TECHNICAL BULLETIN

Poor Idle Quality – Normally Aspirated AJ16 Engine – Valve Timing Modification

12-57

MODEL 4.0L Normally Aspirated 1995 MY DATE 8/95

ILLUSTRATION 1

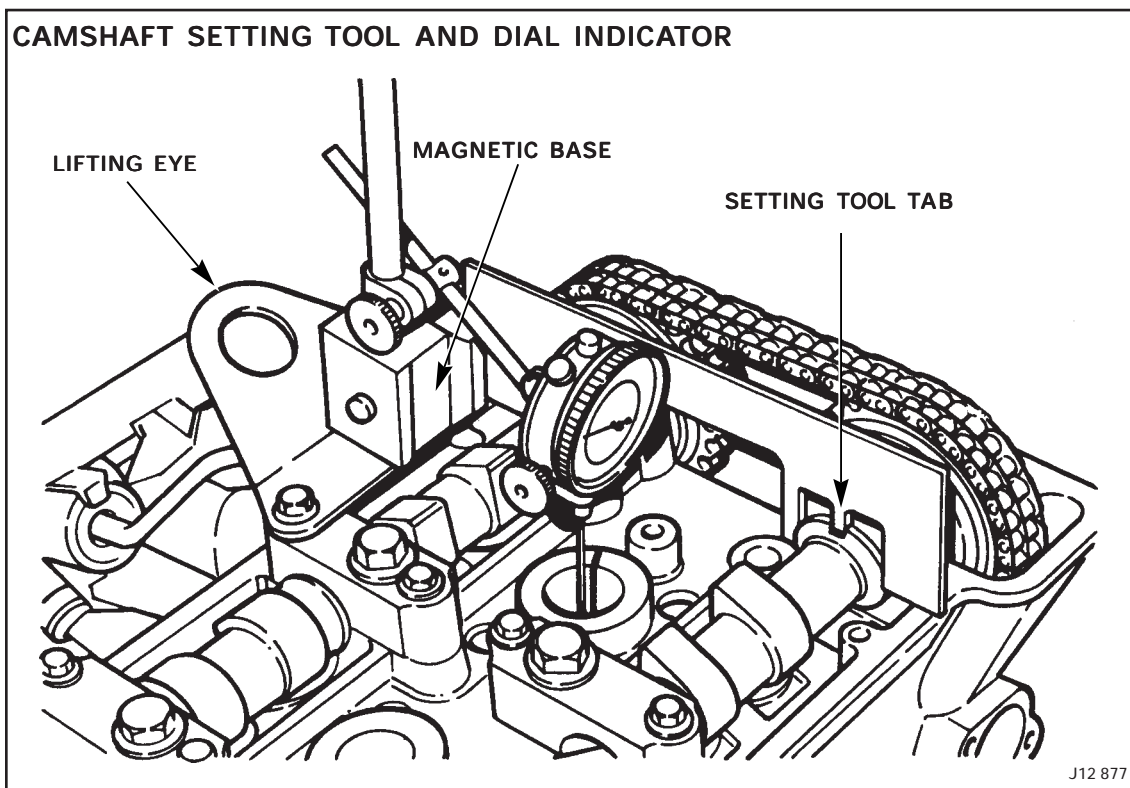
The original camshafts, with a maximum opening position of 110 degrees have been superseded by camshafts with a maximum opening position of 114 degrees. This change is accomplished by machining the camshaft slot in a different

position. The valve timing overlap is reduced from 22 degrees on the 110 camshafts to 14 degrees on the 114 camshafts, Illustration 1.

The maximum opening position of the 114 intake camshaft is 114 degrees after top dead center (ATDC) while the maximum opening position of the exhaust camshaft is 114 degrees before top dead center (BTDC).

5. Turn the crankshaft until the No. 1 cylinder is at Top Dead Center (TDC) on the compression stroke, i.e. with the cam lobes on the No. 1 cylinder pointing upwards as in Illustration 1. This position can be checked by temporarily inserting the camshaft setting tool 18G-1433/A into the slot on each camshaft.

7. On all engines, attach an engine lifting eye to the intake camshaft cap as shown in Illustration 1.
8. Position the magnetic base of a dial indicator gauge on the lifting eye.

ILLUSTRATION 2

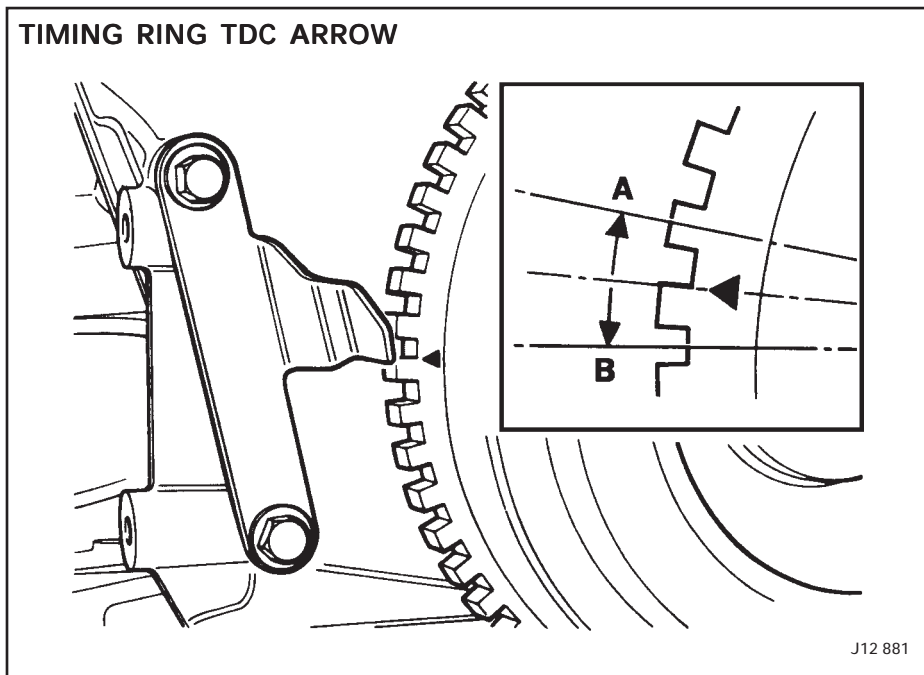
12. Check that the pointer on the front timing cover is in line with the arrowed (TDC) tooth edge on the timing ring, Illustration 2. Realign the pointer if necessary.
13. The crankshaft positions for resetting the camshafts are one and a half teeth on either side of the arrowed (TDC) tooth edge on the timing ring as shown in Illustration 2.
14. Rotate the crankshaft two revolutions in a clockwise direction (viewed from the front of the engine) until the pointer is one and a half teeth before the arrowed (TDC) tooth edge on the timing ring, position A, Illustration 2.

19. Install the locking tabs and the coupling bolts. Lightly tighten the bolts.
20. Remove the setting tool and turn the crankshaft in a clockwise direction (viewed from the front of the engine) until the pointer is one and a half teeth after the arrowed (TDC) tooth edge on the timing ring, position B, Illustration 2.

27. Check both the settings of one and a half teeth before and after the arrowed (TDC) tooth edge on the timing ring, Illustration 2. The tab of the setting gauge should fit in the slot of the camshaft being checked.

ILLUSTRATION 3

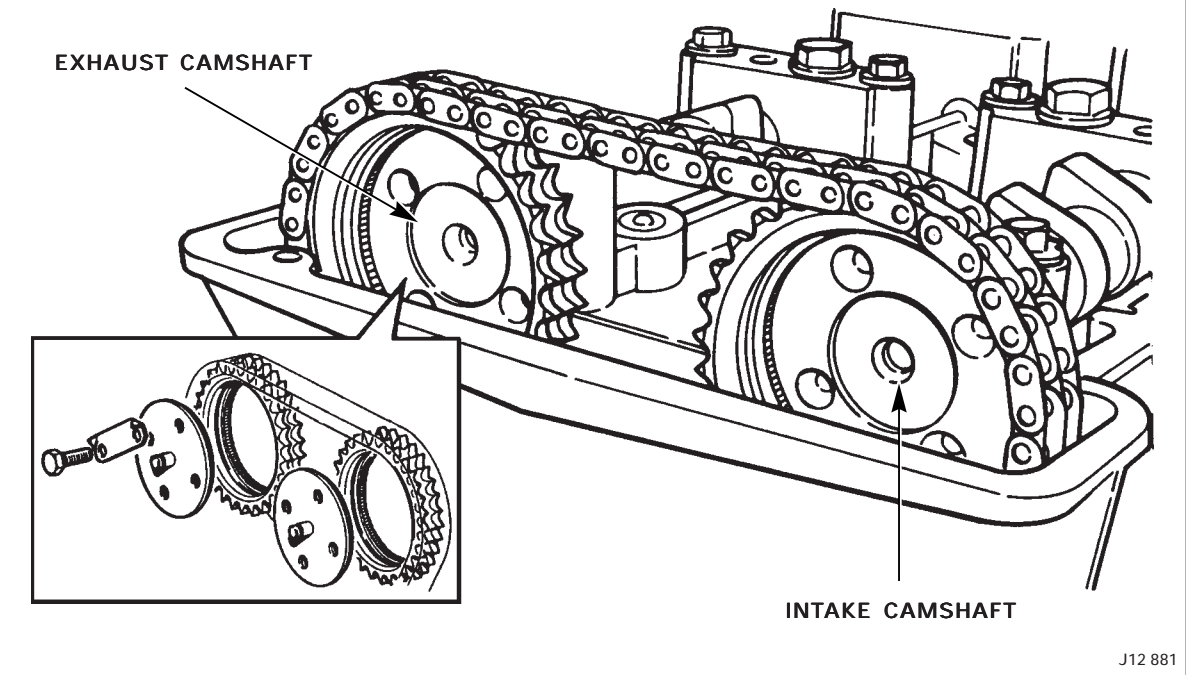
15. Remove the retaining bolts and the camshaft sprocket vernier coupling, Illustration 3, from the exhaust camshaft, but do not detach the sprocket from the camshaft flange. The camshaft is free to rotate inside the sprocket with the coupling removed.
16. Position the camshaft setting tool 18G-1433/A across the camshafts with the positioning tab on the exhaust camshaft, Illustration 1.
17. Turn the exhaust camshaft until the tab on the setting tool engages the slot in the camshaft.
18. With the camshaft in this position, reinstall the sprocket vernier coupling to the exhaust camshaft. This step will require several attempts to find the exact alignment of the vernier splines and the bolt holes.

21. Remove the retaining bolts and the camshaft sprocket vernier coupling, Illustration 3, from the intake camshaft, but do not detach the sprocket from the camshaft flange. The camshaft is free to rotate inside the sprocket with the coupling removed.
22. Position the camshaft setting tool 18G-1433/A across the camshafts with the positioning tab on the intake camshaft.
23. Turn the intake camshaft until the tab on the setting tool engages the slot in the camshaft.
24. With the camshaft in this position, reinstall the sprocket vernier coupling to the intake camshaft. This step will require several attempts to find the exact alignment of the vernier splines and the bolt holes.
25. Install the locking tabs and the coupling bolts. Lightly tighten the bolts.

26. Remove the setting tool and final tighten the camshaft sprocket vernier coupling bolts to 16.2 - 20.6 lb ft (22 - 28 Nm). Bend the lock tabs against the bolt heads.

ILLUSTRATION 4

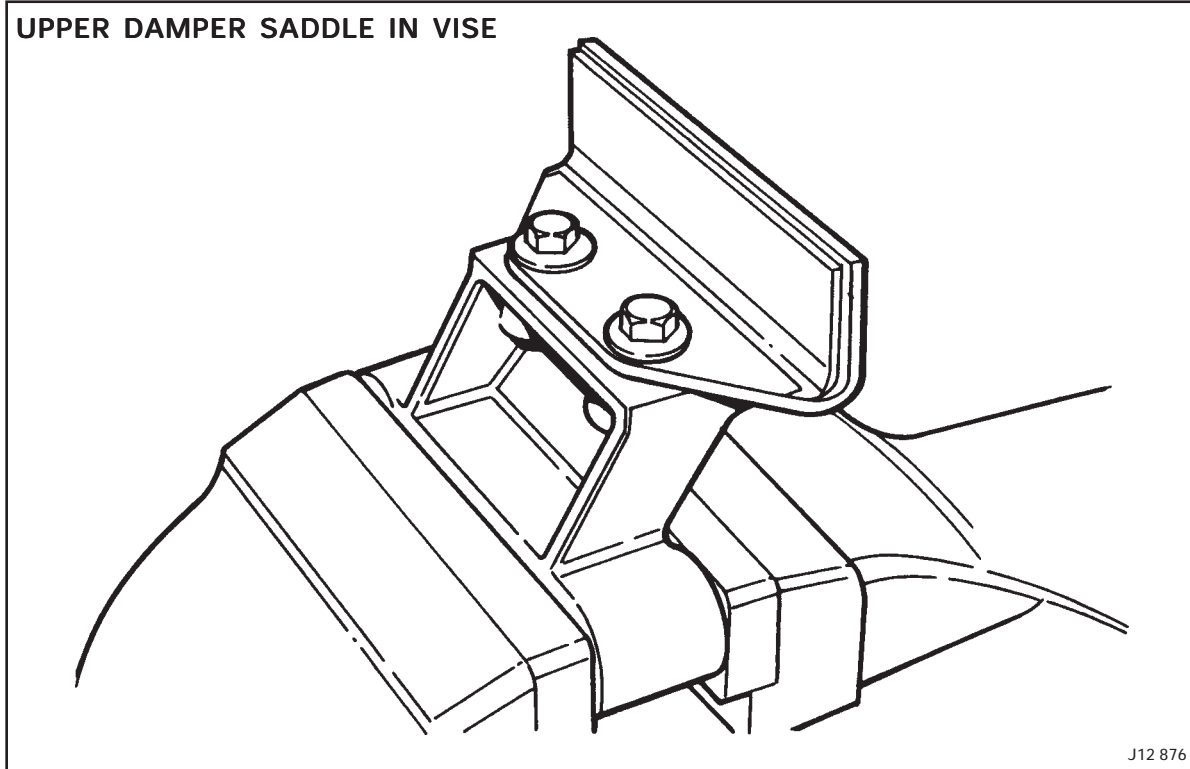
28. Remove the setting tool, the dial indicator gauge, and the lifting eye. Torque camshaft bearing cap bolt to 12.5 - 16.9 lb ft (17 - 23 Nm).
29. On engines with numbers below 9L103934 (XJS Range) or 9J103935 (Sedan Range) only, remove the damper saddle retaining bolts, Illustration 4. Thoroughly degrease the bolts and the saddle. Apply Loctite 545, part number 54531 to the bolt threads and torque to 15.8 - 21 lb ft (21.5 - 28.5 Nm). Install the damper saddle using new cylinder head bolts and torque to 43.5 - 44.9 lb ft (59 - 61 Nm) plus 90 degrees as described in section 2.1 of the AJ16 Engine Service Manual.

NOTE: Engines starting with 9L103934 (XJS Range) or 9J103935 (Sedan Range) do not require modification since the damper saddles are equipped with self locking bolts.

ILLUSTRATION 5

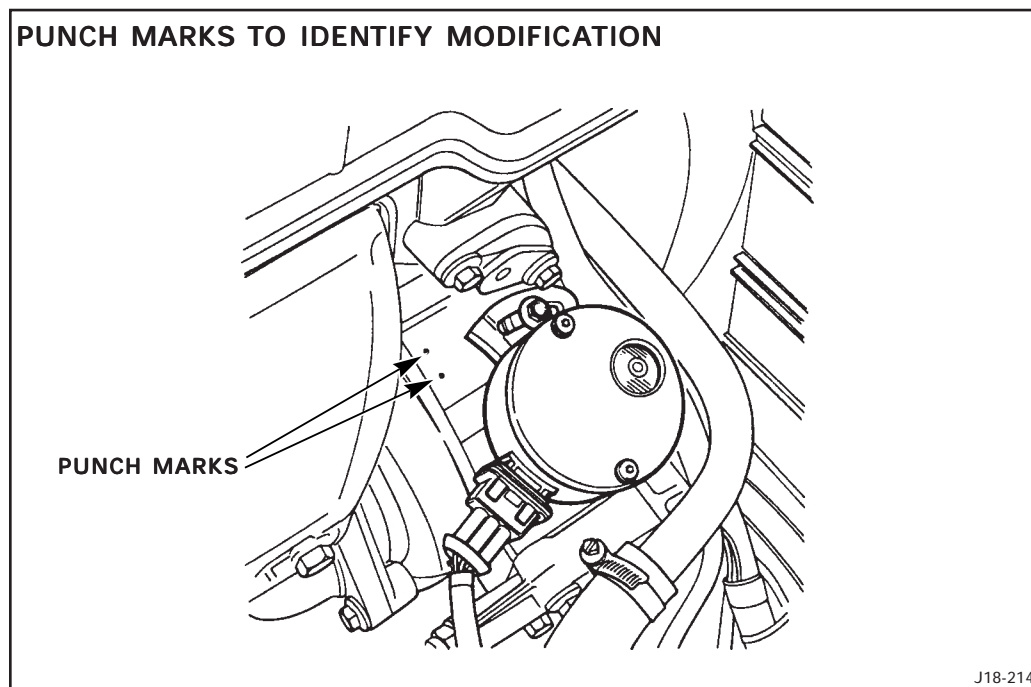
33. Place two punch marks approximately 1/4 inch apart on the timing cover parallel to the lip, Illustration 5, to indicate that the modification was done.
34. Connect the battery negative cable and reset the clock.

In case of a customer complaint of poor idle quality on a vehicle equipped with the 110 camshafts only, first check for punch marks on the timing cover near the camshaft position sensor, Illustration 5, to determine if the timing modification has already been performed. If not, reset the camshaft timing and spark plug gap as described below.
